Response to Absorber-Focus Coil Preliminary Safety Review Panel

2004-07-21

Absorber-Focus Coil Preliminary Safety Review Panel

Figure 2. Revised baseline design for hydrogen system.

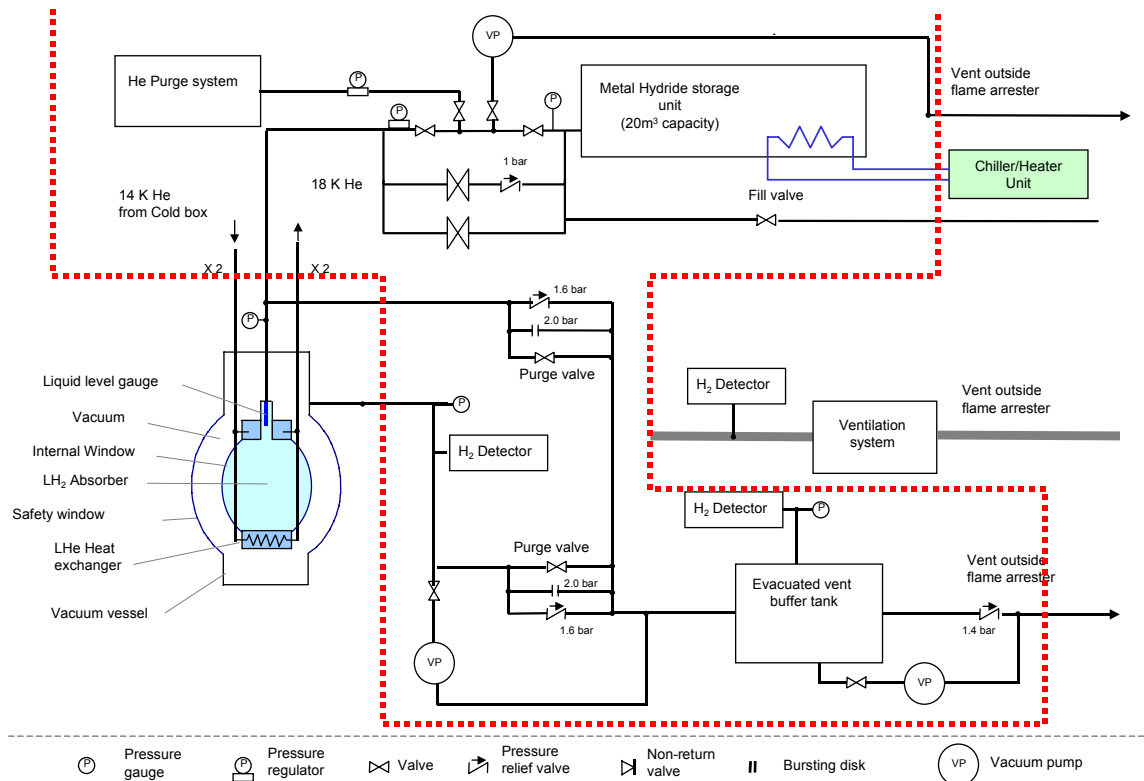
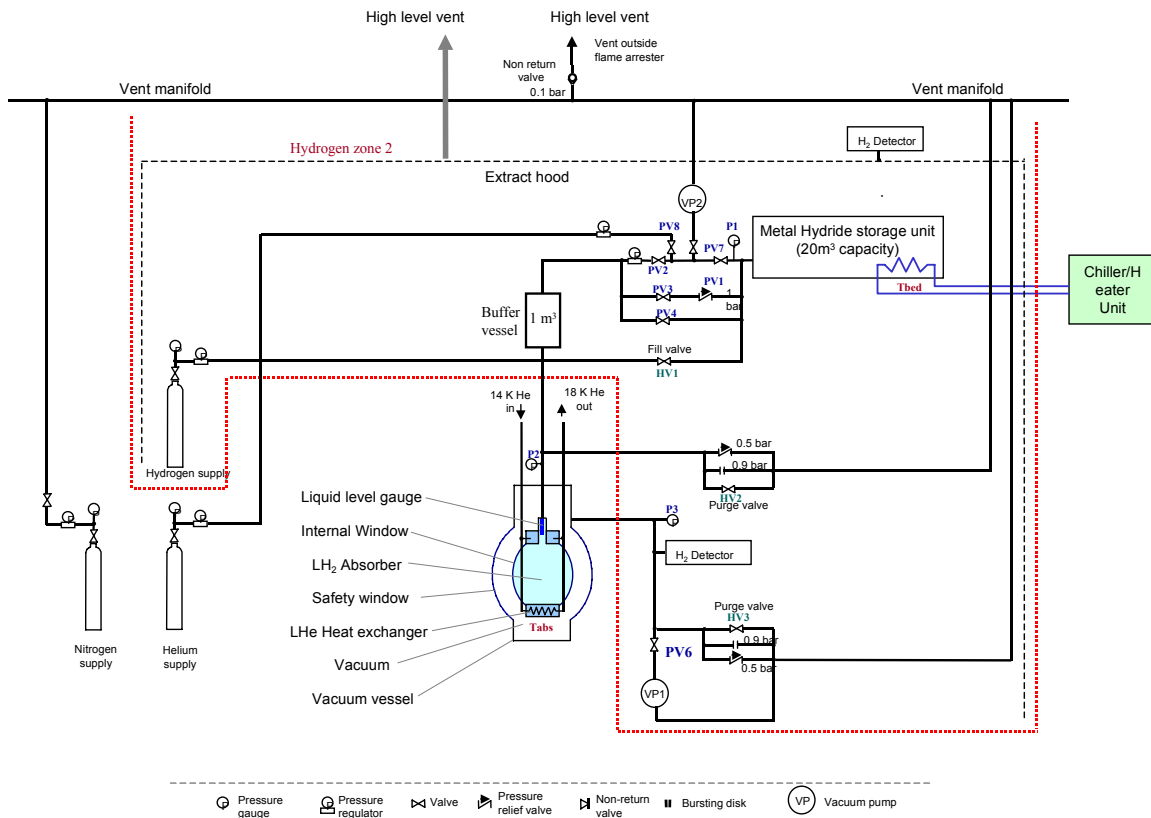
Issue: *Whether the evacuated buffer tank is needed or if it is better just to vent the hydrogen directly outside.*

Issue: *The option of having completely separate vent systems for the absorber and vacuum spaces.*

Issue: *The possible replacement of the flame arrestor with a vent pipe with an inert atmosphere should be considered.*

Response: We have decided that the simpler approach suggested by the Panel has merit and have adopted it. See Appendices 1 & 2.

Response: We have concluded that it is a good idea to have separate vent lines for the absorber and vacuum space. In particular, if a bilge space at the base of the absorber is implemented, then the hydrogen release in the event of a catastrophic event will be more controlled. See Appendix 2.

Response: This change has been implemented in our design.

Our original design, reproduced here in Fig. 1, utilized a common buffer volume for venting both the absorber and its surrounding vacuum space. In both cases, the buffer volume was separated from the working regions by means of relief valves and burst disks. The Panel has convinced us that it is more effective to vent directly to the outside, and we now intend to do so. The RAL safety code does not demand a buffer volume of 52 times the liquid-hydrogen volume, and our finite-element calculations have convinced us that a spill does not develop unsafe pressures in the system. For these reasons, we are satisfied that the current buffer vacuum space, roughly 12 times the liquid-hydrogen volume, provides adequate safety margin.

The updated diagram of the MICE hydrogen system is shown in Fig. 2. As noted earlier, we have adopted suggestions from the Review Panel in the following areas:

- the original buffer vessel on the relief line has been removed
- a venting manifold filled with nitrogen has been added
- separate vent lines for the absorber and the absorber vacuum space have been implemented

In addition, we have added a 1 m³ buffer vessel on the input line between the hydride bed and the absorber. After studying the layout more carefully, we have decided to eliminate the ventilation system in favor of placing most of the hydrogen equipment within the hydrogen extraction hood.
